**Re: Second Submission Review: Project Waterfall Site Plan and Plat**  
**Application Number:** DA-2284-02  
**Case Numbers:** 2024-6024-00; 2024-3023-00

## *Second Submission Review*

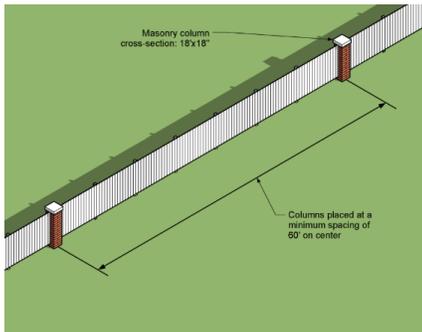
4A. Thank you for including a sidewalk from the patio to the eastern edge. Staff would still like to see a gate along the eastern edge for pedestrians to directly connection to the sidewalk along the private road. The sidewalk that runs to the southern edge along the gatehouse does directly connect with the sidewalk, and staff finds the site plan meets the code intent of a main entry having direct pedestrian access to a street.
